HEARING DATE: April 6, 2023

TO: Planning & Zoning Commission

SUBJECT: Modern Craftsman Franklin AZ, CUP, MDA, PP, PS H-2022-0079
(aka Colorado Ridge)

C. Common/Shared Access Drive Exhibit – *NOT APPROVED AS A COMMON DRIVEWAY (TO BE APPROVED AS A PRIVATE STREET)*

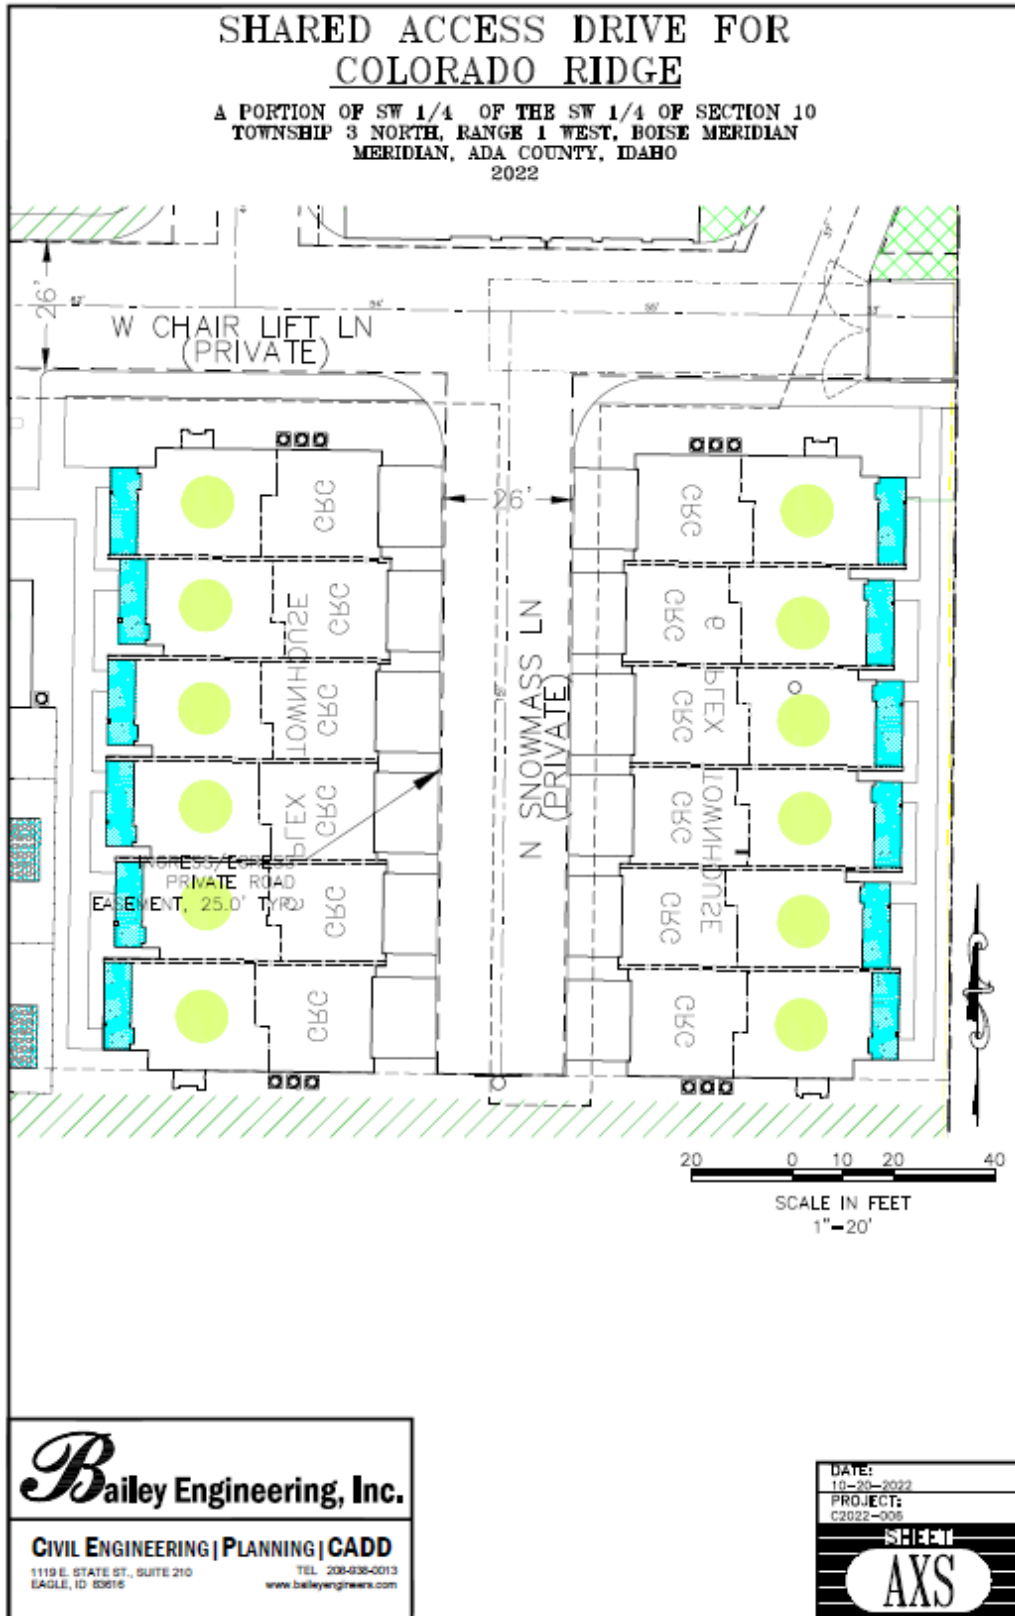
Private streets are proposed for internal access within the development and are required to comply with the standards listed in UDC [11-3F-4](#). **Staff recommends the private streets are constructed on a lot within the subdivision rather than an easement as set forth in UDC 11-3F-4A.1; revise the plat accordingly. Where the private street connects to a public street (i.e. W. Aviator St.), the connection shall be approved by ACHD. The private streets should be constructed in accord with the standards listed in UDC 11-3F-4B.2.**

- a. Remove the street sections for N. Moshova Ave. and depict a drive aisle instead of a public street on the plan. The drive aisle shall be located along the west property to ensure the parcel to the west can utilize the access. Depict a sidewalk along the drive aisle for pedestrian connectivity and safety.

Sheet Number:
L3

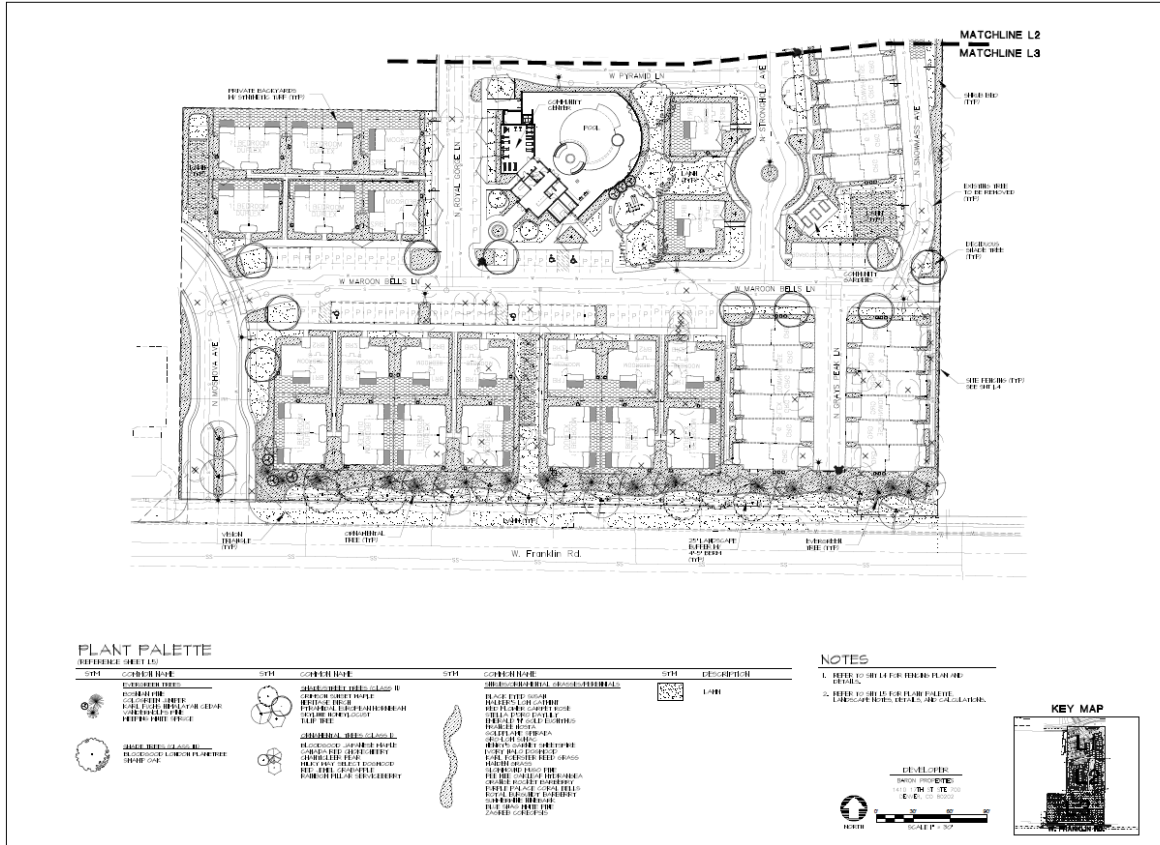
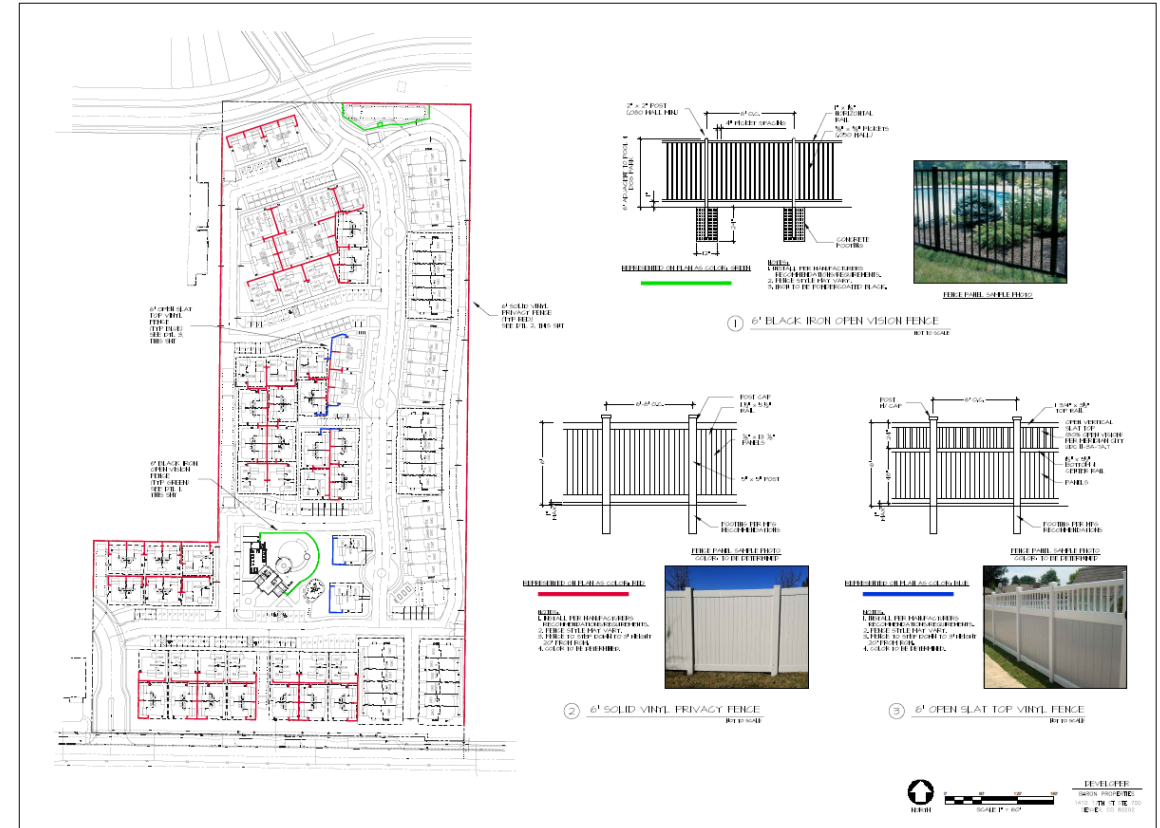
All common open space areas are required to be landscaped with one deciduous shade tree for every 5,000 square feet of area and include a variety of trees, shrubs, lawn or other vegetative groundcover per UDC [11-3G-5B.3](#). **Shrubs should be added to common open space areas and the calculations table on the landscape plan (Sheet L5) should be updated to demonstrate compliance with this standard.**

There are several existing trees on this site that will be removed with development as depicted on the landscape plan. **Mitigation is required to be provided per the standards listed in UDC [11-3B-10C.5](#); calculations demonstrating compliance should be included on the landscape plan submitted with the Certificate of Zoning Compliance and/or final plat application.**

- b. Depict landscaping within the 20-foot wide street buffer along W. Aviator St. in accord with the *updated* standards listed in UDC [11-3B-7C](#). An 8-foot wide parkway is required along the collector street planted with Class II trees and a 6-foot wide detached sidewalk as set forth in the TMISAP (Street Section C). Include the linear feet of buffer with the number of required vs. provided trees in the Landscape Calculations table on Sheet L5 that demonstrates compliance with UDC standards.

- 2.2 The landscape plan submitted with the final plat shall include the following revisions:
 - a. Include mitigation calculations on the plan for existing trees that are proposed to be removed in accord with the standards listed in UDC [11-3B-10C.5](#).
